E7917A-03

S E R V I C E N O T E

E7917A 2-Port OC-3c/12c ATM Routing Test Card

**Sometimes E7917A fails to power up.
Applies to any units not modified to A10 indicated by the label on the main
PCA as shown in Figure 1 and Figure 2.**

Figure 1 - Identification

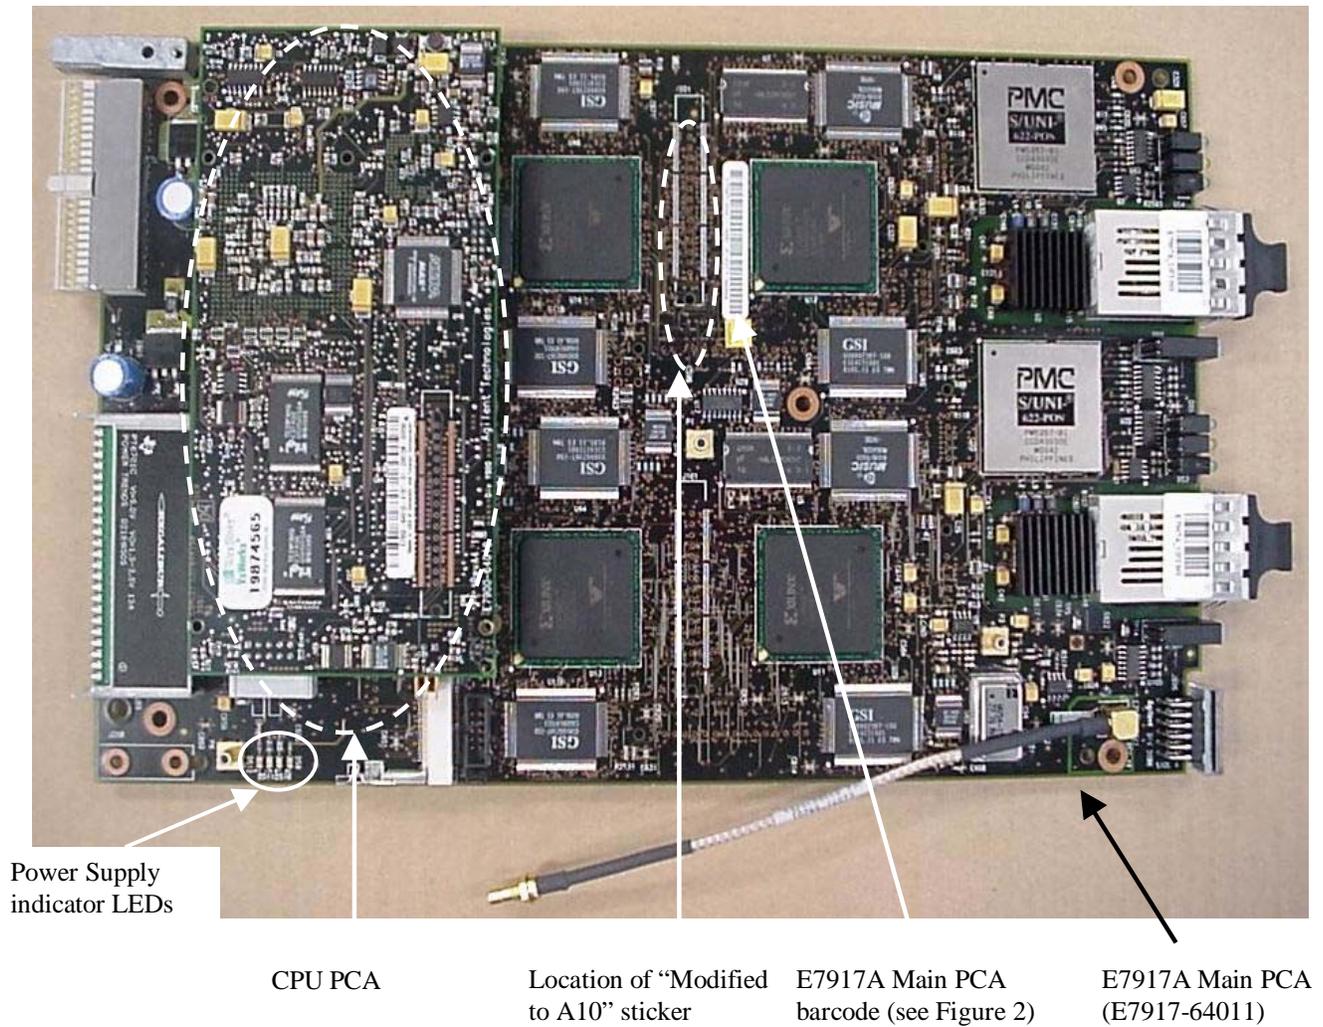
The failure of the E7917A Test Card to power up is detected by the absence of any LED activity on the front panel of the Test Card. Alternatively, in an open RouterTester 900 4-Slot Chassis (E7900A) the power supply LED indicators (located at the rear left of the E7917A Test Card) fail to light when the Chassis is powered up, refer to Figure 1 on page 3.

1. Remove the E7917A Test Card from the E7900A Chassis.
2. Determine the current revision of the E7917A main PCA as follows (see Figure 1 below):
 - If a sticker is found on the E7917A main PCA indicating “Modified to A10” or “Modified A10”, no further work is required. Do not confuse with a potentially similar sticker on the CPU PCA.
 - If the E7917A main PCA barcode sticker indicates A10, no further work is required. Refer to Figure 2 below where the barcode sticker indicates PCA revision A09. In the absence of a “Modified to A10” sticker, the modification will be required.
 - The E7917A main PCA barcode sticker is generally located near U12, however on earlier versions of the PCA this sticker was randomly positioned on either side of the PCA by the Contract Manufacturer.
 - Do Not confuse the barcode sticker on the CPU PCA with that of the main E7917A PCA sticker.

16. Check that the E7917A TestCard power rail indication LEDs are all lit. Refer to Figure 1 on page 3 for their location on the main PCA. If any of these LEDs fail to light, re check the capacitor solder joints.
17. Check that the E7917A TestCard has correctly numbered up (refer to the Built In Self Test section of the E7900A service manual for further information).
18. Execute the Automated diagnostics section of the E7900A service manual with the E7917A TestCard in slot number one of the E7900A chassis to verify that operation of the E7917A TestCard.
19. End of process.

Figure 2 - E7917A PCA identification Barcode

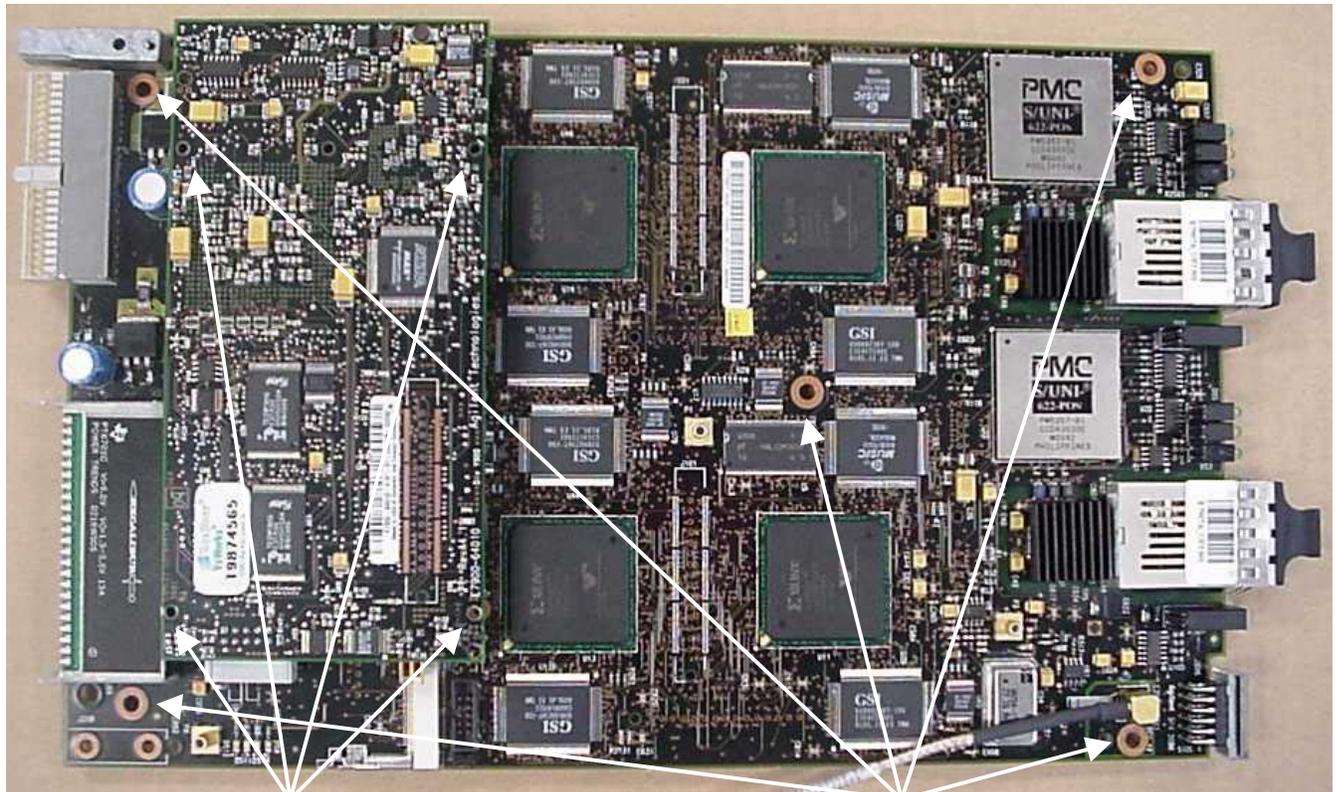
PCA Modification / Revision number

Figure 3 - Retaining Screw Positions

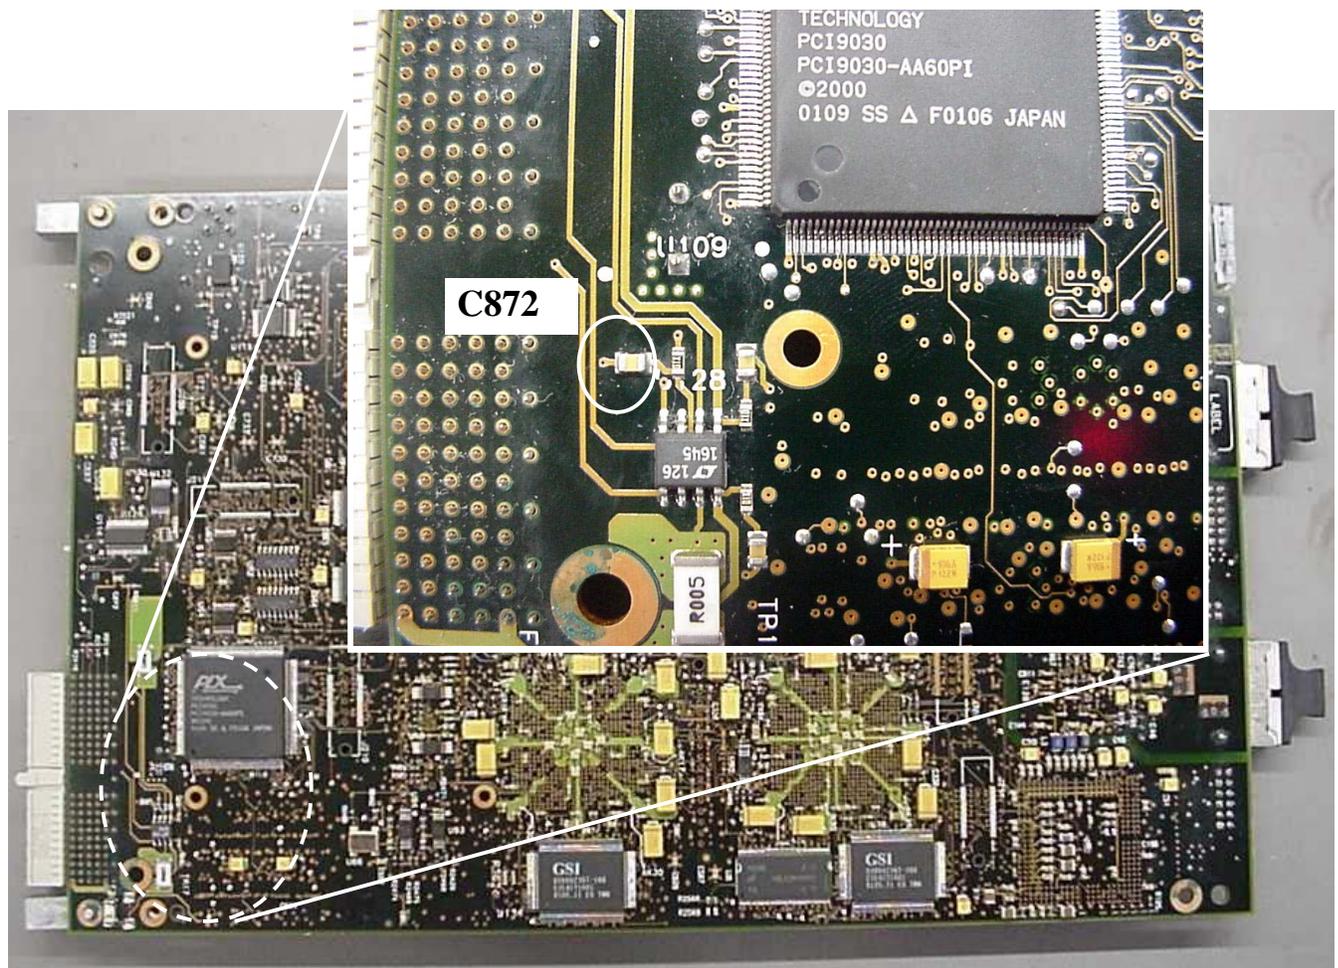
3. Remove the retaining nut of the SMB connector on the E7917A Test Card front panel and pull the cable clear.
4. Remove the four retaining screws of the CPU PCA and carefully remove the PCA from the main E7917A Test Card PCA, refer to Figure 3 below
5. Remove the six retaining screws of the main E7917A Test Card PCA, refer to Figure 3 below. Slightly raise the rear of the PCA so that the standoff's are clear of the underside of PCA to ensure that no surface mount components are knocked off the PCA and slowly pull the PCA optics modules clear of the front panel.

Note: The sixth E7917A Test Card PCA retaining screw, location not shown above, is positioned in the center of the PCA directly under the leading edge (closer to the front panel) of the CPU PCA.
